Agenda Item # 3

SUB-002811-2024

Cody Road Subdivision

- Subdivision approval to create one (1) legal lot of record from two (2) metes-and-bounds parcels.

SITE PLAN

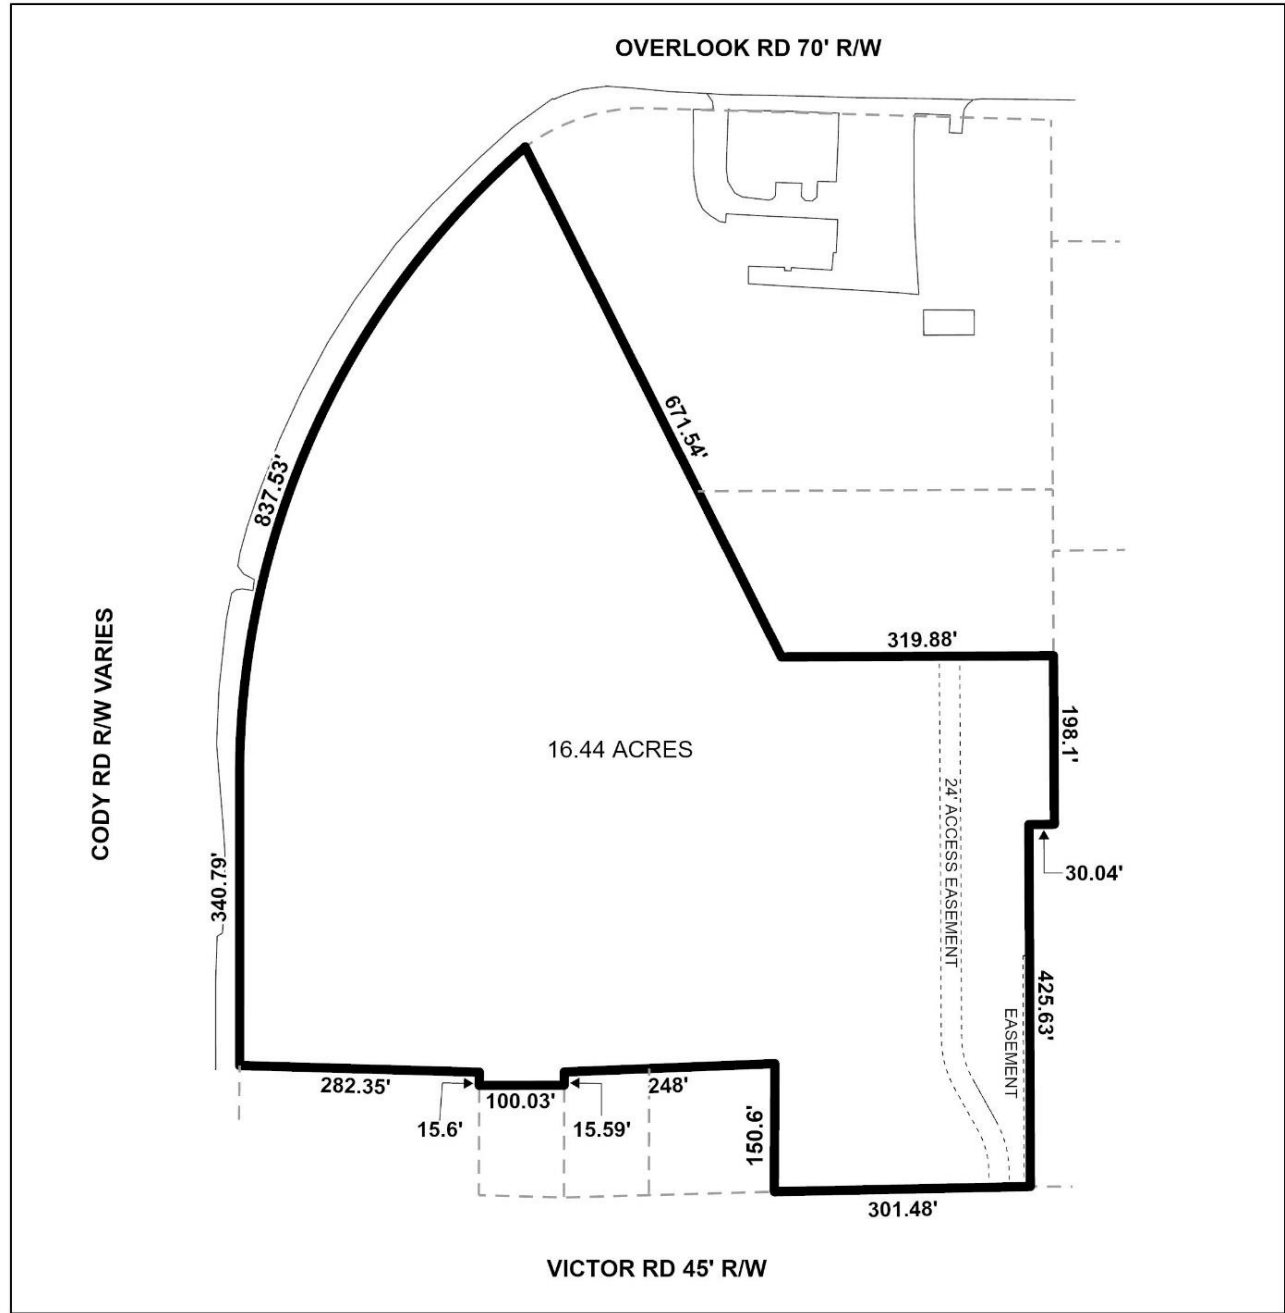
The site has frontage along Cody Road North, Overlook Road, and Victor Road. Cody Road North is a Major Collector street without curb and gutter requiring a 100-foot right-of-way, Overlook Road is a minor street without curb and gutter requiring a 60-foot right-of-way, and Victor Road is a minor street with a ribbon curb and gutter requiring a 50-foot right-of-way. The Preliminary Plat depicts a varying right-of-way along Cody Road North, a 70-foot right-of-way along Overlook Road, and a substandard, 45-foot right-of-way along Victor Road. As mentioned, Cody Road North requires a 100-foot right-of-way. Furthermore, rezoning of the property to R-3 required dedication sufficient to provide 50 feet from the centerline of Cody Road. As such, if approved, the plat should be revised to depict compliance with this requirement. A 70-foot right-of-way is depicted along Overlook Road and is sufficient.

Regarding Victor Road, if approved, the plat should be revised to illustrate dedication sufficient to provide 25 feet from its centerline.

A 25-foot front yard setback is not illustrated along any street frontage, as required by Section 64-2.7.E. of the Unified Development Code (UDC) for lots in an R-3 Suburban District. The Final Plat should be revised to depict this information, if approved, adjusted for any required dedication.

The proposed lot is not labeled. If approved, the lot should be labeled on the Final Plat (e.g. Lot 1, Lot A, etc.).

The subdivision is labeled as "Orchard Park" on the preliminary plat, but the application indicates the proposed subdivision will be named 'Cody Road Subdivision.'" The applicant will need to verify with staff the correct name of the subdivision prior to signing of the Final Plat, if approved.

Finally, a 25-foot wide access easement is illustrated on the plat, extending from Victor Road to an adjacent lot to the North. A note on the plat states no structure shall be constructed or placed within any easements without the permission of the easement holder. If approved, this note should be retained on the Final Plat.

1. Revision of the plat to depict dedication sufficient to provide 50 feet from the centerline of Cody Road North;
2. Revision of the plat to depict dedication sufficient to provide 25-feet from the centerline of Victor Road;

3. Retention of the right-of-way along Overlook Road, as depicted on the preliminary plat;
4. Revision of the plat to illustrate a 25-foot setback along all street frontages, adjusted for dedication;

6. Provision of a lot label on the Final Plat;
7. Correction of the name of the Subdivision on the Final Plat;
8. Retention of a note on the Final Plat that states that no structures shall be constructed on any easement without permission from the easement holder;

9. Compliance with all Engineering comments noted in this staff report;
10. Placement of a note on the Final Plat stating all Traffic Engineering comments noted in this staff report;
